RECEIVE AND FILE COMMUNICATION FROM THE
PLAN AND ZONING COMMISSION REGARDING PROPOSED SKYWALK REPLACEMENT
OVER PARK STREET BETWEEN 4TH STREET AND 5TH AVENUE

Communication from the City Plan and Zoning Commission advising that at their meeting held November 17, 2016, the following action was taken regarding a request review and recommendation to the City Council regarding a proposed Skywalk replacement over Park Street between 4th Street and 5th Avenue, to allow connection of the Iowa Events Center Hilton Hotel project to the Skywalk system.

The Park Street Skywalk bridge would span between the Iowa Events Center Hilton Hotel, under construction on the north side of Park Street, and an existing office building to the south. See attached rendering, plan, and elevations.

Concept Perspective
OCTOBER 21, 2016

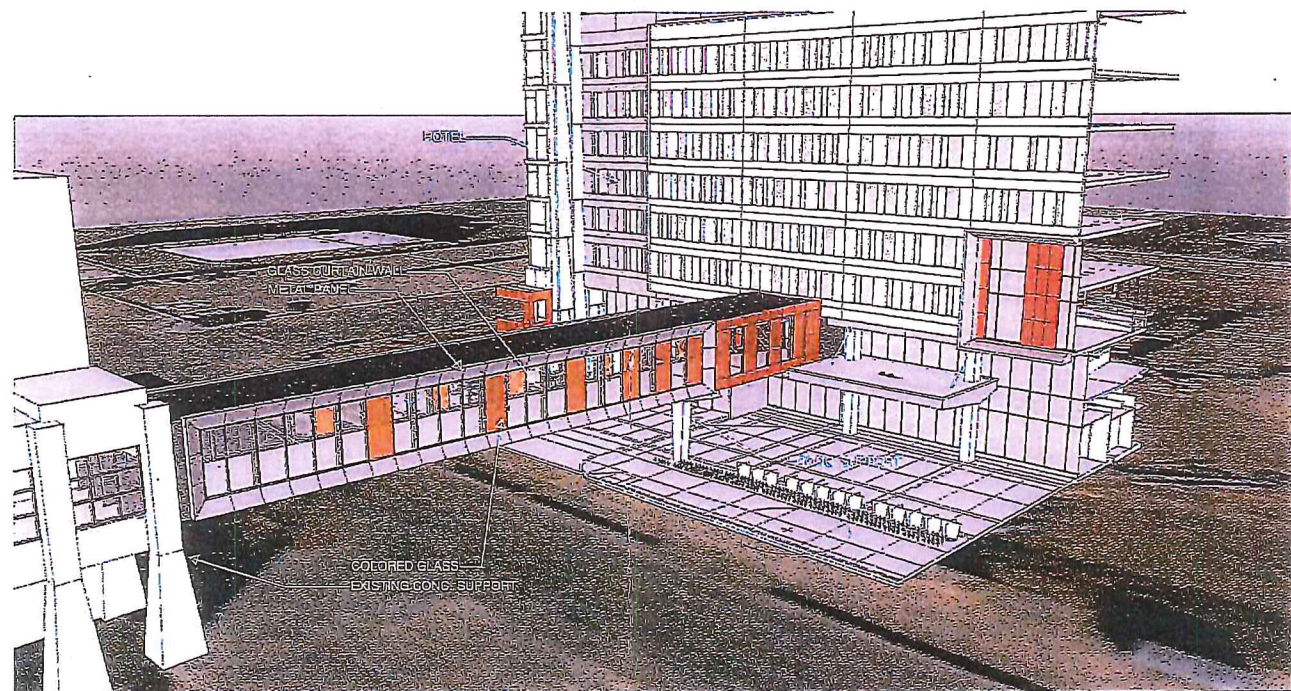
- The UDRB liked the idea of the “picture frame” on the sides of the bridge over the ROW portion, but suggested that the remaining section over the private property be made as transparent as possible, not opaque. Full glass will allow public to place themselves in the environment right before entering the building.

- Recommended exploring the use of the same material as the hotel for the grey metal portions of the skywalk.
- Consider eliminating the sequential patterning as it works against the picture pane notion. It appears to draw unnecessary attention to what is typically an understated, translucent pedestrian walkway over the streets.

- Be careful how the portion outside the frame intersects the building itself. A more translucent element is recommended.
- It is awkward to have the Skywalk path slope down to get into the hotel only to go back up once in the building.

- Prefer Skywalks that try to be neutral within their surroundings. There is a series of Skywalks Downtown that try to be an extension of the building with which they were built. This notion becomes challenging for the new structures that go up. Skywalks that delicately or subtly bridge are the most successful.

- Recommended expanding on the details of the way the skywalk intersects the hotel.
- This is a tough geometry to tackle given the elevation set for the hotel building and the need to meet clearance for the Park Street grade. When you have a tough, complicated problem you look for the simplest solution. Recommended making it as simple as possible.

Staff for the UDRB recommended consideration of a resolution of the slight bridge slope with an exterior enclosure and also requested additional information regarding integration to the hotel of mechanical, electrical, and roof drainage.
